**Re: Defect Information Report – Supplemental Report No. 1  
11V-008, FL-587, M2 Seat Belt Anchor Backing Plate**

## Subject: Freightliner Business Class M2 Seat Belt Anchor Backing Plates

March 2011  
FL587A  
NHTSA #11V-008  
Transport Canada #11-010

**Fig. 1, Locations of Inboard Tether Anchor Backing Plates**

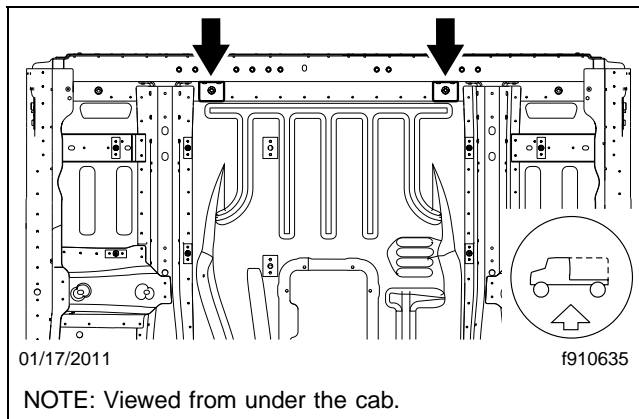
1. Check the base label (Form WAR259) for a completion sticker for FL587 (WAR260) indicating this work has been completed. The base label is usually located on the passenger-side door about 12 inches (30 cm) below the door latch. If a completion sticker is present, no further work is needed. If a completion sticker is not present, proceed to the next step.
2. Shut down the engine, set the parking brake, and chock the tires.
3. Under the cab, inspect the backing plates for the *inboard* tether belt anchors. They are located on the underside of the cab floor, just inboard of the longitudinal reinforcements, as shown in **Fig. 1** and **Fig. 2**.

**Fig. 2, Tether Belt Backing Plate**

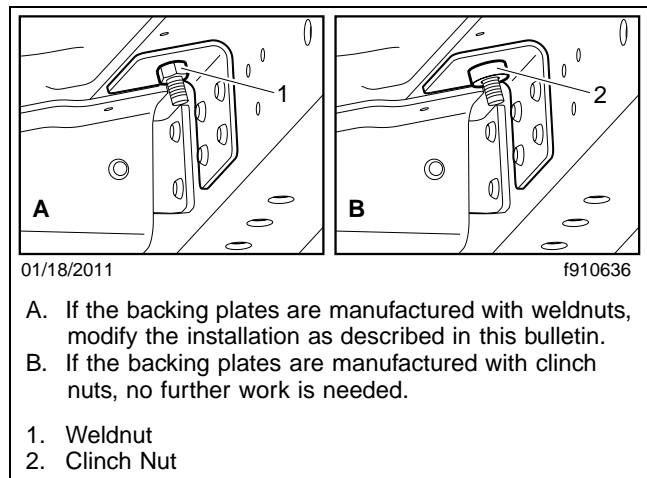
If the backing plates are manufactured with *clinch nuts*, no further work is needed. Clean a spot on the base label and attach a completion sticker for FL587 to the base label.

If the backing plates are manufactured with *weldnuts*, continue to the next step and modify the installation as follows.

**Fig. 3, Inboard Tether Belt Anchor Bolts**

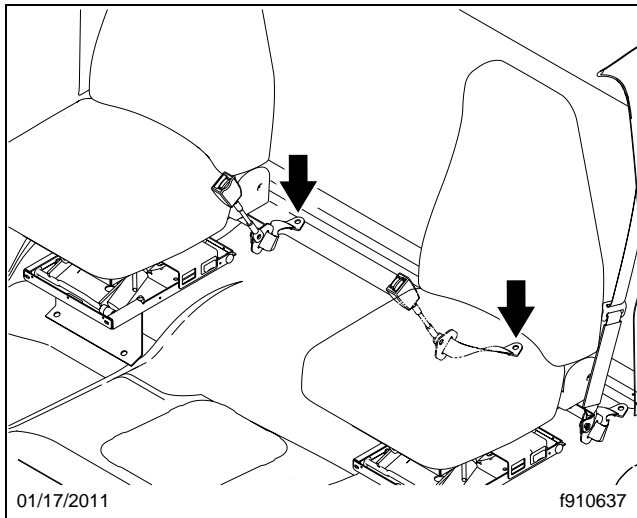
4. From inside the cab, remove the 1-1/2-inch long bolts from both the *inboard* tether belt anchors. Discard the bolts and the paper retaining washers, if present. See **Fig. 3**.

**IMPORTANT:** Do not reuse tether anchor bolts that have been torqued to full load.

**Fig. 4, Modified Tether Mount Backing Plate Installation**

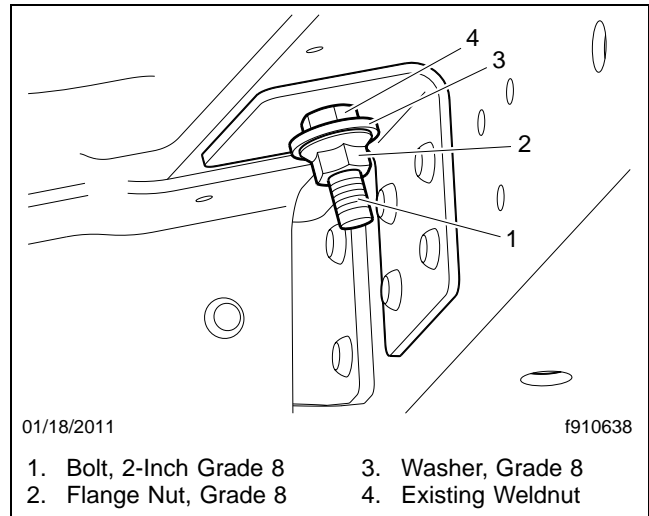
5. Install a new 2-inch long, grade 8 bolt (23-09439-200) and grade 8 washer (23-09114-001) from the kit at each inboard tether anchor. Tighten the bolts 35 to 45 lbf-ft (48 to 60 N·m).
6. Under the cab, install a grade 8 washer (23-09114-017) and a grade 8 flange nut (23-13223-007) from the kit on each bolt. See **Fig. 4**. Tighten the flange nuts 35 to 45 lbf-ft (48 to 60 N·m).
